October 21, 2004

Re: Proposed Trumbull Home Subdivision
Stanford Road
Engineering and Environmental Review

RE: Sight Distance Provisions
Millbrook, NY

OUTCHESSE COUNTY DEPT. OF PUBLIC WORKS	
HIGHWAY STANDARDS	
SIGHT DISTANCE MEASUREMENTS	
SCALE: 1" = 20'	DATE: 2/1988
FIGURE A-1

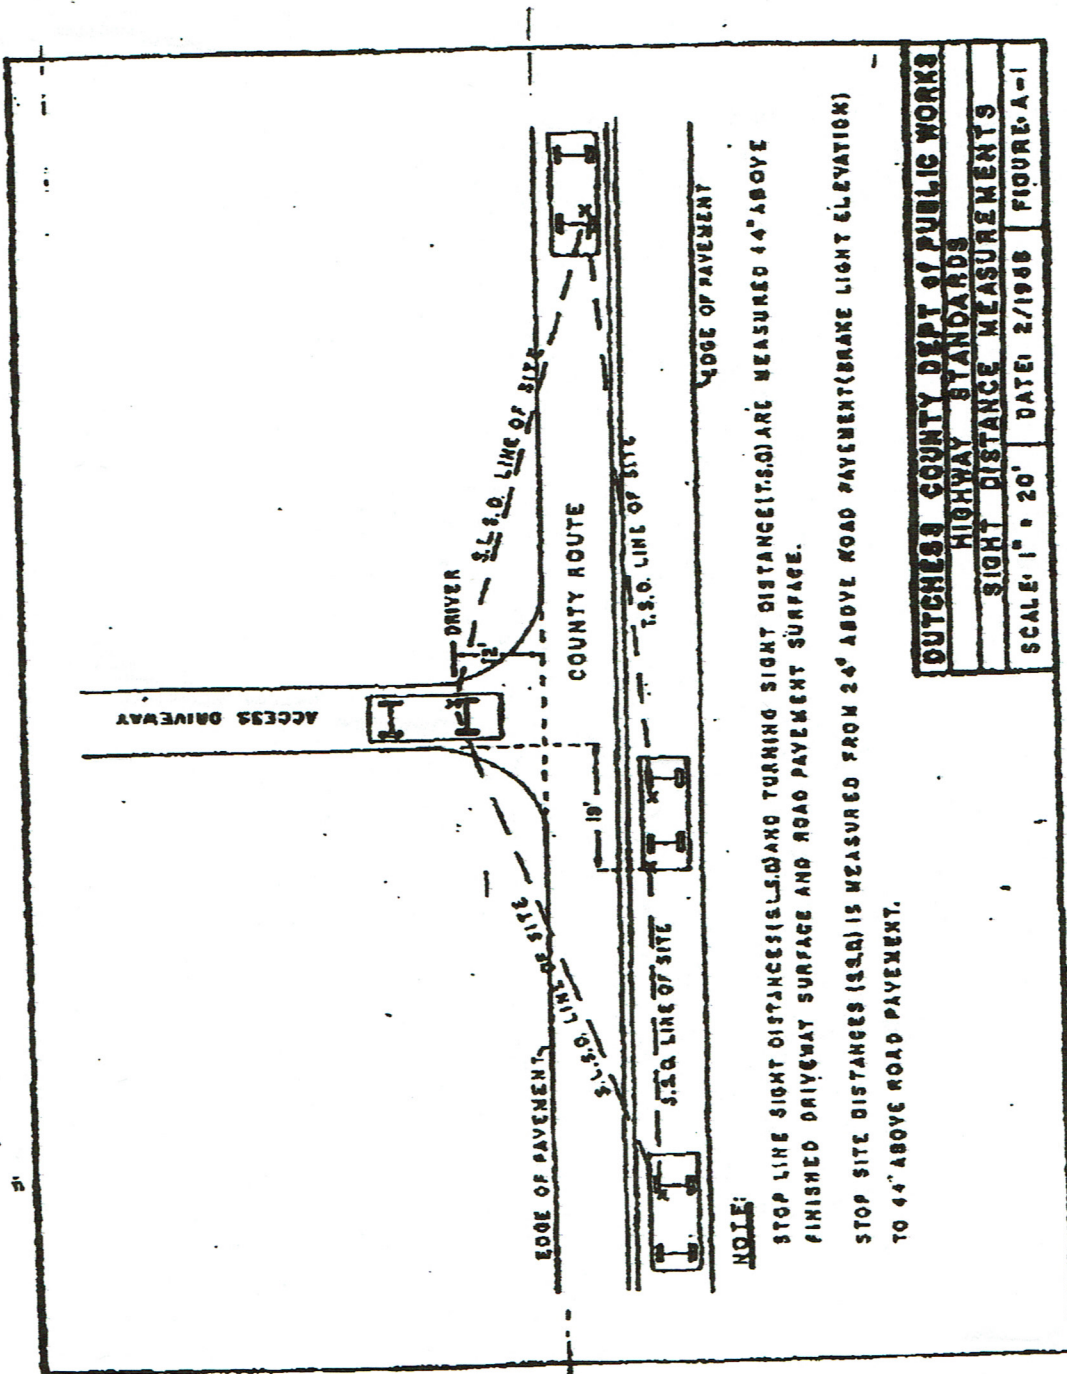
Our March 1, 2004 comment letter recommended using Dutchess County Highway sight distance standards, which require greater sight distance lengths (even when applied to level roadways), **and** with additional sight distance lengths when applied to accommodate steep existing roadway grades. These referenced Dutchess County Highway sight distance standards indicate that additional stopping sight distance must be added to that shown for level terrain when the roadway grade exceeds 3%. As an example, this County sight distance standard table shows that 50 feet must be added to the minimum sight distance length requirements on a 35 mph roadway when the grade is 9%. This 9% is the steepest grade shown in this County table of sight distance standards. **As a comparison to show the severity of the deficiency in the Town's standards, the grade of Stanford Road near the proposed driveway location is 13%, yet no additional sight distance length is required in the Town's standards.**

Sight distance requirements for vehicles entering and exiting roadways are established by various agencies including the American Association of State Highway and Transportation Officials (AASHTO) and the Dutchess County Department of Public Works. The intersection required sight distance design criteria is a function of the travel speeds on the roadways. For example, as shown in the attached excerpt from the Dutchess County Standards, the intersection design criteria for a 40mph roadway requires a minimum of 275 feet of sight distance for the safe stopping sight distance along the roadway and a recommended intersection turning sight distance of some 412 feet. Both of these distances would also have to be increased for downgrades. A 6% downgrade would increase these distances by 40 feet.
